## URGENT FIELD SAFETY NOTICE / PRODUCT NOTIFICATION

**Subject:** Specific NDI Polaris Spectra Cameras installed on Brainlab Curve and Kick Navigation Systems were delivered with an incorrect manufacturer calibration, affecting the use of active marker registration instruments with the navigation system, especially relevant for the Z-touch Laser Pointer patient registration with Cranial or ENT navigation software.

**Product Reference:** Specific Curve and Kick Navigation systems.

**Brainlab Identifier:** CAPA-20200624-002355

**Picture 3: Registration accuracy verification page example, illustrating the resulting deviation on a phantom.**

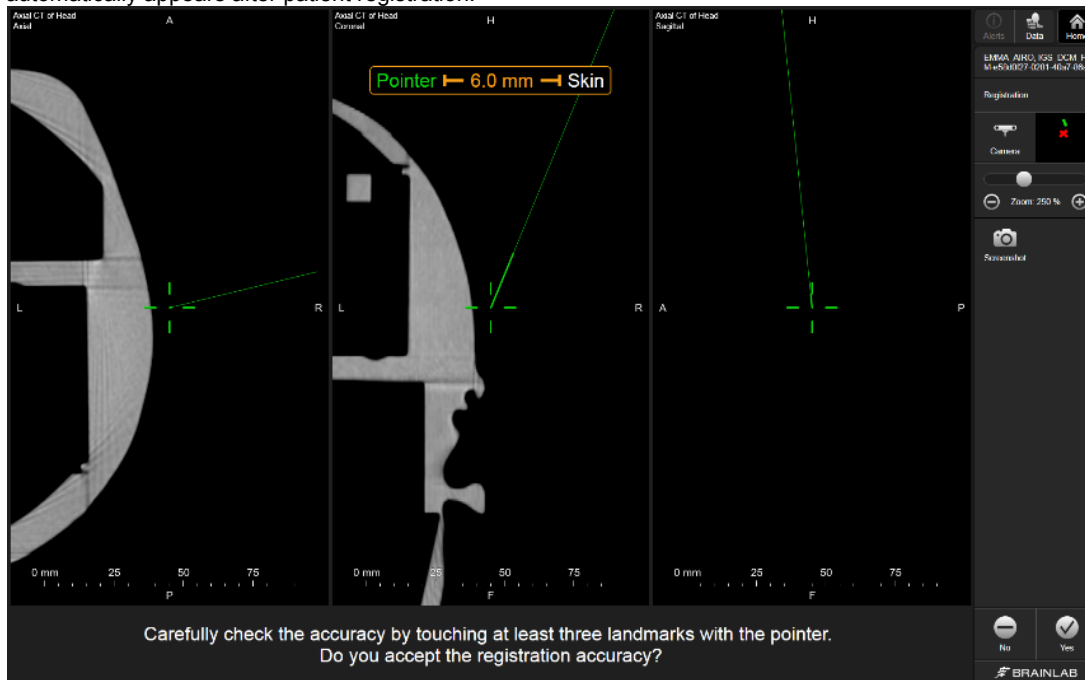
The locations of the acquired laser registration points are misinterpreted by an affected camera and deviate by ca. 6 mm from the actual position. The points are consistently shifted in left / right direction of the camera. That means, that with an affected camera, the registration accuracy achieved with a Z-touch Laser Pointer for Cranial or ENT navigation, deviates visibly by about 6mm.

The resulting registration accuracy is visible in the verification page that appears automatically after the registration is calculated, with the verification page instructing for adequate accuracy check and active acceptance by the user before being able to proceed with the navigation.

The required adequate verification process makes the shift obvious, and therefore demonstrates the effectiveness of the design measures for accuracy verification.

Illustration: the deviation due to this issue is visible in the registration accuracy verification page that automatically appears after patient registration:

1. Refer to the appendix for the list of Brainlab Curve or Kick Navigation Systems with an affected camera installed to determine if your navigation system is affected.
2. **For Cranial or ENT navigation software in combination with an affected system camera installed: Do not use the Z-touch Laser Pointer for patient registration.** Use other instruments with the standard instrument pivoting method for Surface Matching or Landmark Registration, or Automatic Image Registration (AIR) if available.
3. Please continue to follow the instructions and warnings as described in the user guide. Especially relevant is the following warning, in addition to the instructions on the registration verification page appearing in the Cranial or ENT software:

**Verify accuracy at multiple anatomical landmarks, especially in the region of interest, as it may differ from the accuracy verified on the skin surface. If the region of interest is not accessible, verify in areas as close as possible to the region of interest.**
